UNITED STATES
DEPARTMENT OF THE INTERIOR
BUREAU OF LAND MANAGEMENT

SUNDRY NOTICES AND REPORTS ON WELLS
Do not use this form for proposals to drill or to re-enter an abandoned well. Use Form 3160-3 (APD) for such proposals.

8. Well Name and No.
China Federal #12

**China Federal 12
30-005-61659
Vanguard Operating, LLC
October 31, 2018
Conditions of Approval**

AFTER P&A

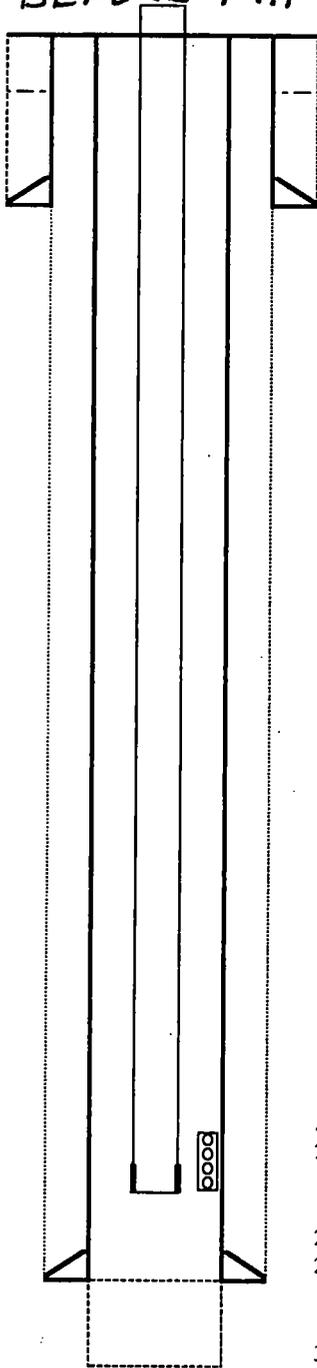
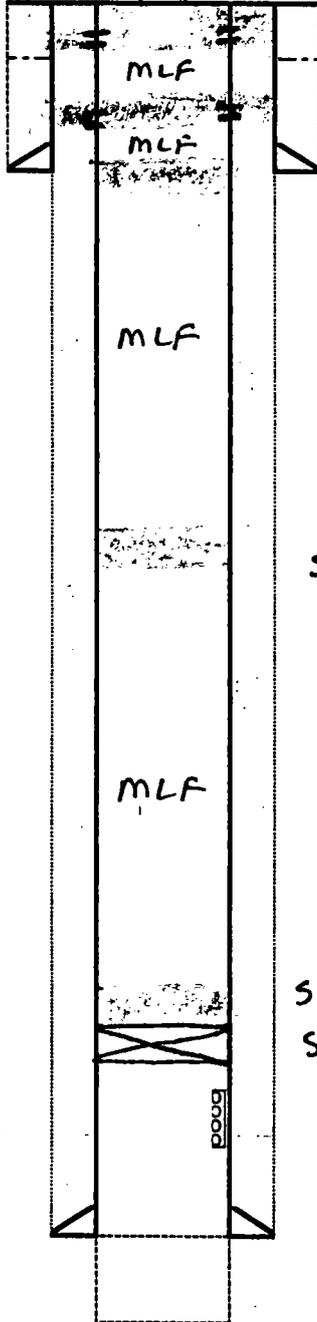
1. Notify BLM 24 hrs prior to MIRU to P&A.
2. Set CIBP @ 2736' RIH w/tbg & tag CIBP circ hole w/MLF & test csg, spot ²⁵ 20 sx's class "c" cmt F/2736'-2636' WOC & tag if csg don't test.
3. Spot 20 sx's class "c" cmt F/2000'-1900' (Tubb) spot 20 sx's class "c" cmt F/1552'-1452' (8 5/8" Shoe).
4. Perf @ 700' sqz 60 sx's class "c" cmt 700'-380' WOC & tag (Yeso, Glorieta). ^{330'}
5. Perf @ 100' circ cmt to surf 4 1/2" & 4 1/2" x 8 5/8" csg's WOC verify.
6. RD P&A equip, cut off wellhead, install dry hole marker, clean location & move off.

- 1. Operator shall place CIBP 50'-100' above top most perf and place 25 sx of Class C cement on top to seal the Abo Formation. WOC and TAG.**
- 2. Operator shall place a Class C cement plug from 2,000'-1,900' as proposed. WOC and TAG.**
- 3. Operator shall place a Class C cement plug from 1,552'-1,452' as proposed to seal the 8-5/8" shoe. WOC and TAG.**
- 4. Operator shall perf at 700' and squeeze cement as proposed. Operator shall place a Class C cement plug 700'-330' as proposed to seal the Glorietta Formation. WOC and TAG.**
- 5. Operator shall perf and squeeze at 100'. Operator shall place a Class C cement plug from 100' to surface as proposed.**
- 6. See Attached for general plugging stipulations.**
